Addendum No. 3 Bishop International Airport Authority Signage and Wayfinding

Project name:	Signage and Wayfinding	Client:	Bishop International Airport Authority
Project location:	Flint, MI	Client representative:	Christopher Yeates
Project number:	2715900-230638.01	Mead & Hunt, Inc. manager:	John Paul Minear
Date:	November 21, 2025	Mead & Hunt Inc. phone:	608-443-0459

Addendum No. 3
Wayfinding & Graphics

SIGN TYPE 100.A INTERIOR OVERHEAD DIRECTIONAL / SPANDREL MOUNT OPTION (SIZE 1)
SCALE: AS NOTED

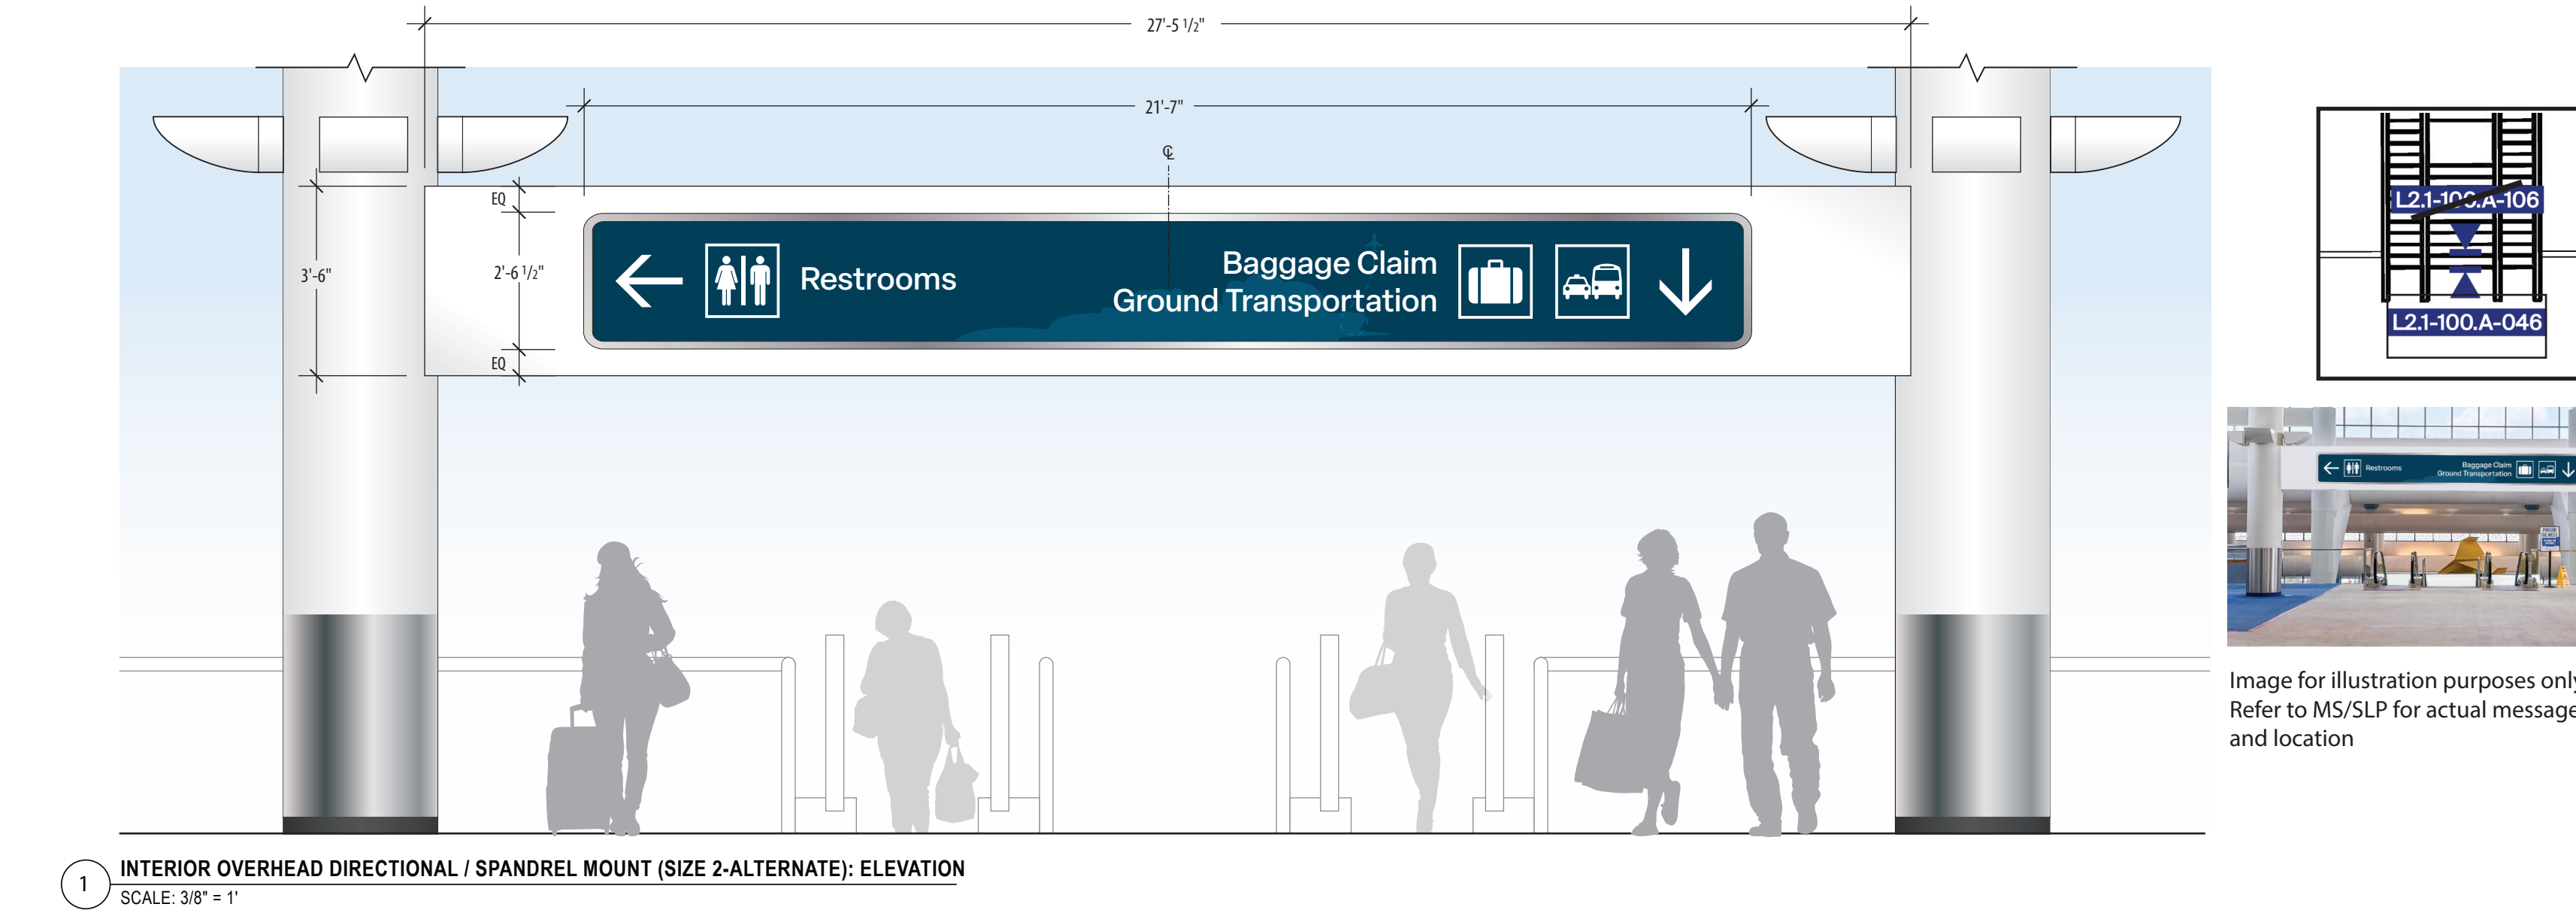
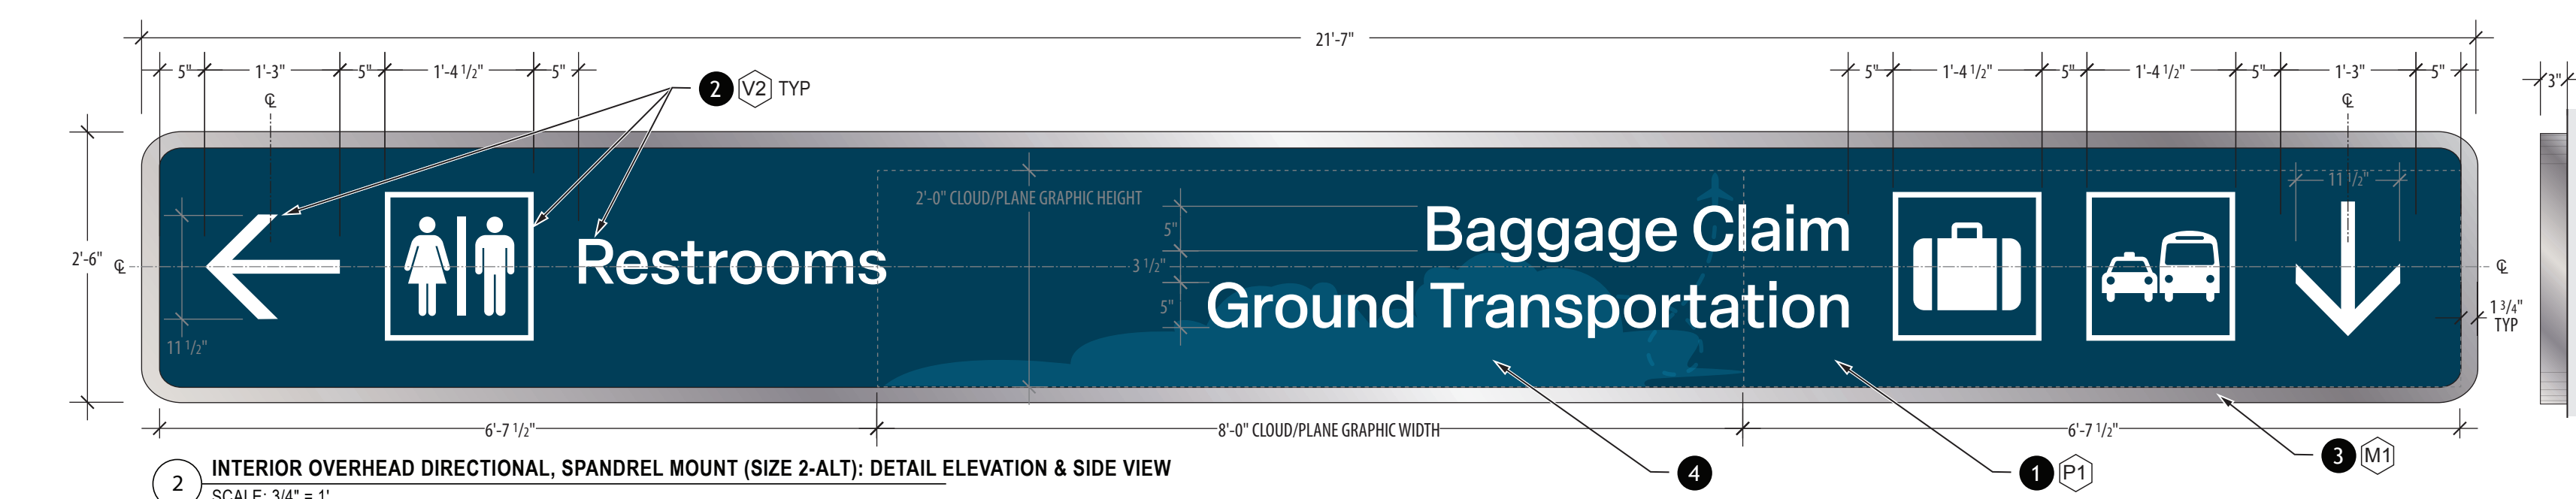
- e. Q5. For the 100 series Signs Types the bid form notes size 1, 2, and 3; but only 2 lengths are noted on the drawings. Please clarify:
A5. All lengths are indicated on drawings. The sign type descriptions were incorrect on bid form-it will now match sign drawing description.

Demolition Plan

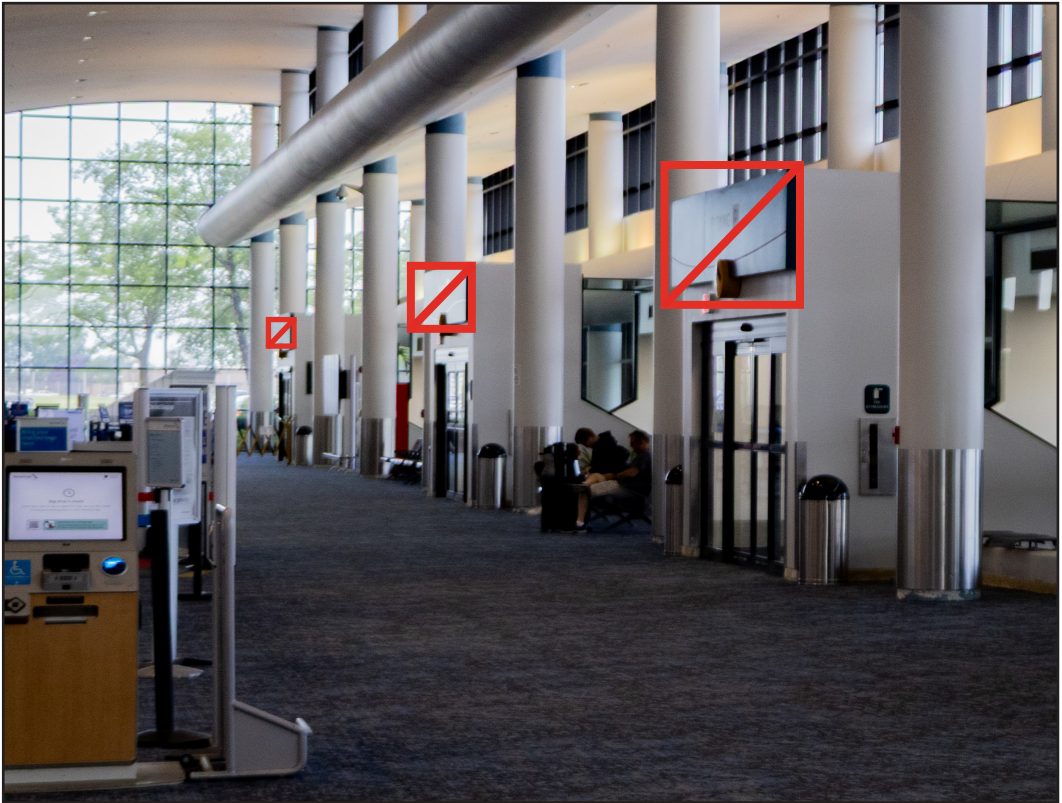
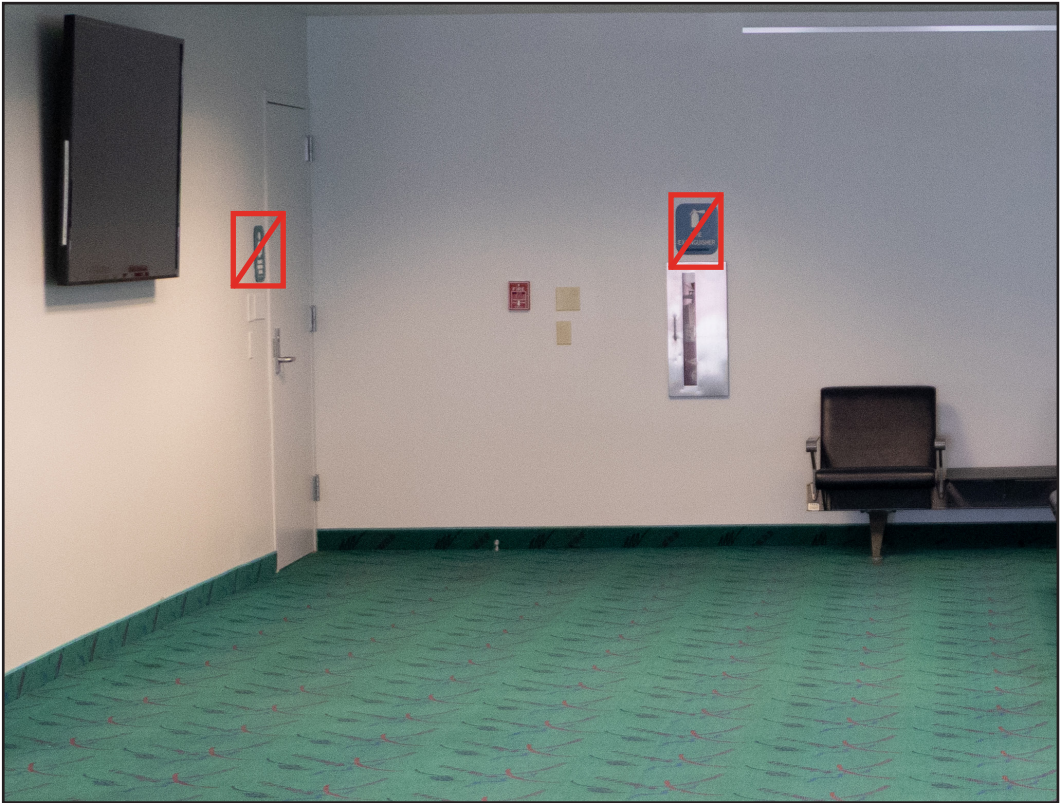
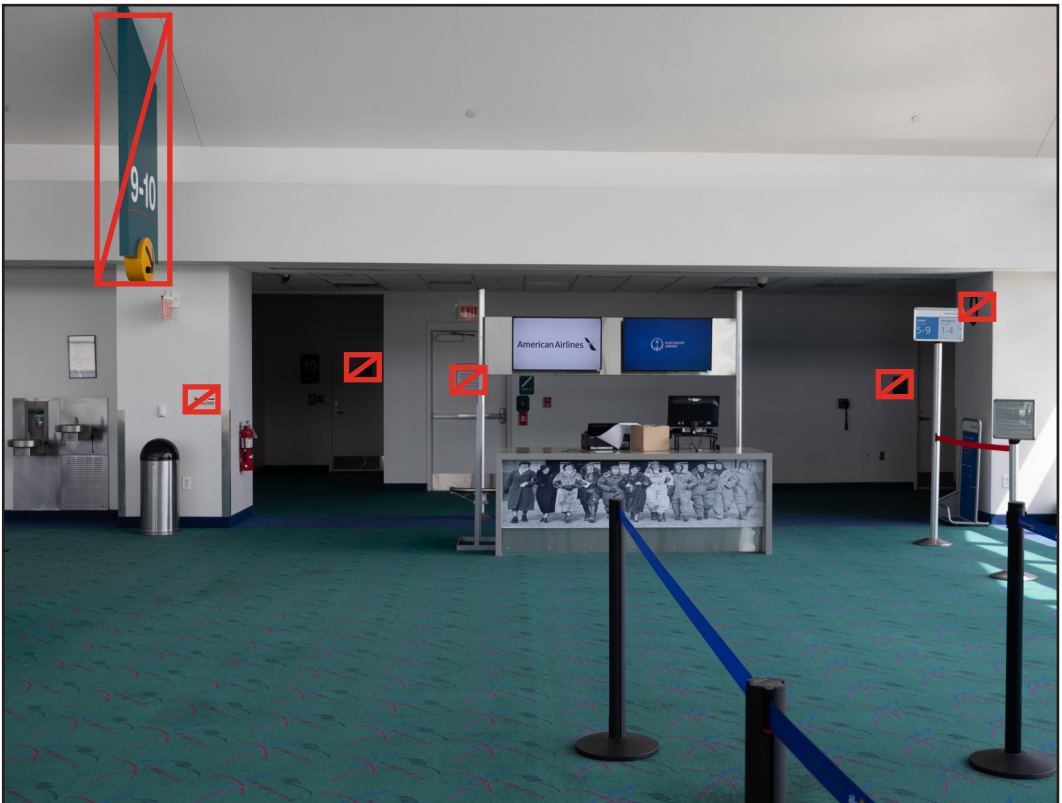
- a. Q1. Are we expected to repair the structure that the large hanging signs are attached to, above the escalators when we remove them?
A1. Yes. Patch, repair and paint.

RED HIGHLIGHTS
AREAS TO BE
REMOVED AND
RE-PATCH OR
FIXED.

RED HIGHLIGHTS
AREAS TO BE
REMOVED AND
RE-PATCH OR
FIXED.

RED HIGHLIGHTS
AREAS TO BE
REMOVED AND
RE-PATCH OR
FIXED.
